APPLICATION NUMBER: **25/1044**

PROPOSAL: **DEMOLISH GARAGES AND ERECT PAIR OF SEMI-DETACHED DWELLINGS**

SITE: **Land West of 10 Thompson Avenue Newport NP19 4LY**

APPLICATION TYPE: **Full**

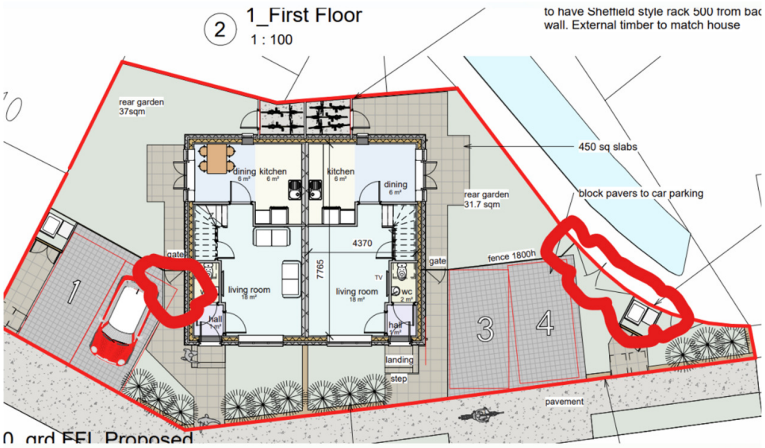
As commented on previous application the proposals are very tight for the site. Likely pinch points are highlighted below. Proposals are still shown on an OS base which is not sufficiently accurate. There may be more space once a topographic survey is provided, equally there may be less - for such a tight site with an adjacent stream corridor a topographic survey should be used as a base plan.
